UNITED STATES PATENT AND TRADEMARK OFFICE

APPLICATION NO.	FILING DATE	FIRST NAMED INVENTOR	ATTORNEY DOCKET NO.	CONFIRMATION NO.
10/625,734	07/24/2003	Naoto Fujishima	1639.1008D	8062
21171	7590	12/10/2004	EXAMINER	
STAAS & HALSEY LLP SUITE 700 1201 NEW YORK AVENUE, N.W. WASHINGTON, DC 20005			NGUYEN, KHIEM D	
			ART UNIT	PAPER NUMBER
			2823

Office Action Summary	Application No.	Applicant(s)	
	10/625,734	FUJISHIMA, NAOTO	
	Examiner	Art Unit	
	Khiem D Nguyen	2823

FIG. 8

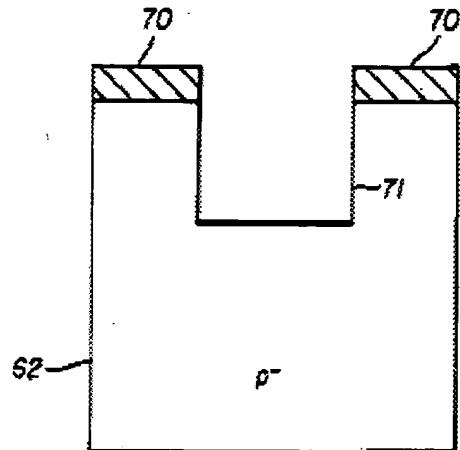
forming a trench 71 in a surface region of a semiconductor substrate 62, of a first conductivity type (p-type) (col. 7, lines 6-17 and FIG. 8);

FIG. 13a

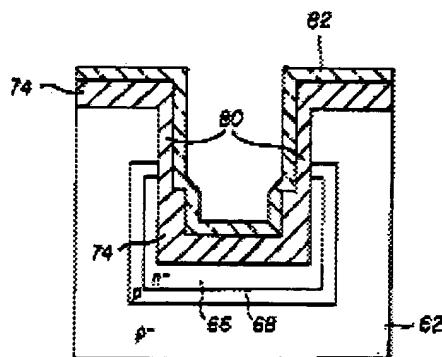
forming a drift region, of a second conductivity type, around the trench (Abstract);
forming a gate insulating film 80, having a uniform thickness, along a side surface and a bottom surface of the trench and inside the trench and forming a first conductor 82 along a surface of the gate insulating film (col. 7, lines 19-31 and FIG. 13a),

FIG. 15a

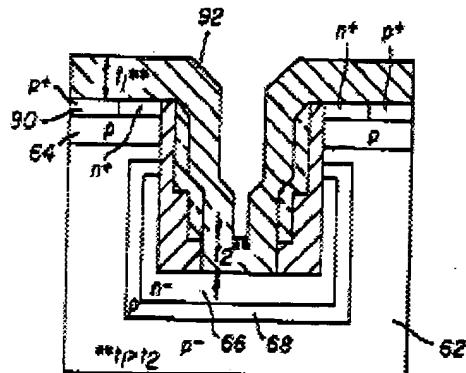
etching back the first conductor in an active region so that the first conductor remains only in side surface regions of the trench (col. 7, lines 32-57 and FIG. 15a);

FIG. 16b

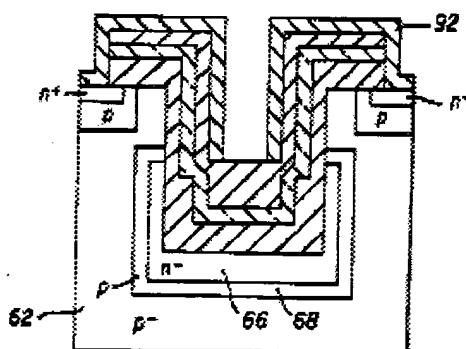
forming a base region (p-) of the first conductivity type (p-type), and a source region (n+), of the second conductivity type (n-type), in a surface region of the semiconductor substrate outside the trench (col. 7, lines 32-57 and FIG. 16b);

FIG. 15b

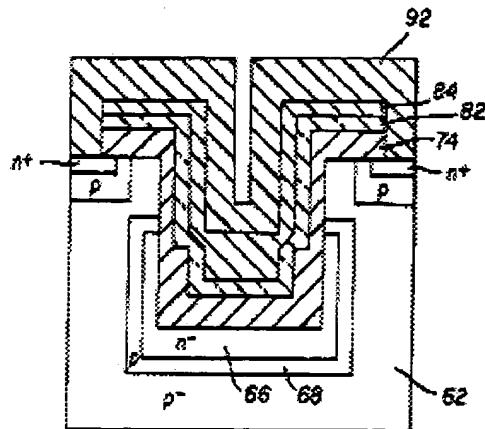
forming an interlayer dielectric 84 inside the first conductor (col. 7, lines 19-30 and FIG. 15b);

FIG. 16a

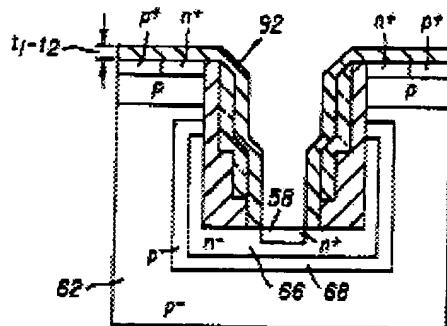
selectively removing a bottom of the interlayer dielectric in the active region; forming a drain region 58 of, the second conductivity type (n-type), at the bottom of the trench (col. 7, lines 32-57 and FIG. 16a); and

FIG. 18a

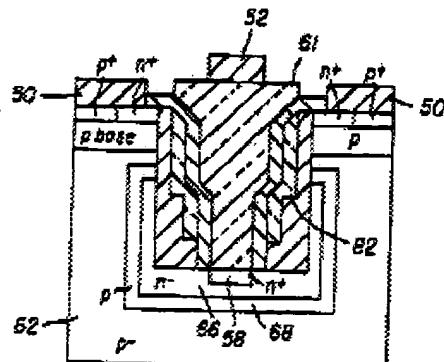
forming a second conductor 61 in the trench, the second conductor electrically connecting to the drain region (col. 7, lines 32-57 and FIG. 18a).

In re claim 2, Fujishima discloses that the method for manufacturing a semiconductor device of claim 1, further comprising: forming an interlayer dielectric 80 on a surface of the semiconductor substrate 62, opening contact holes through the interlayer dielectric (col. 7, lines 32-57), forming a gate electrode 54 that electrically connects to the first conductor 82, a drain electrode 52 that electrically connects to the second conductor 61, and a source electrode 50 that electrically connects to the source region (FIGS. 18a-b).
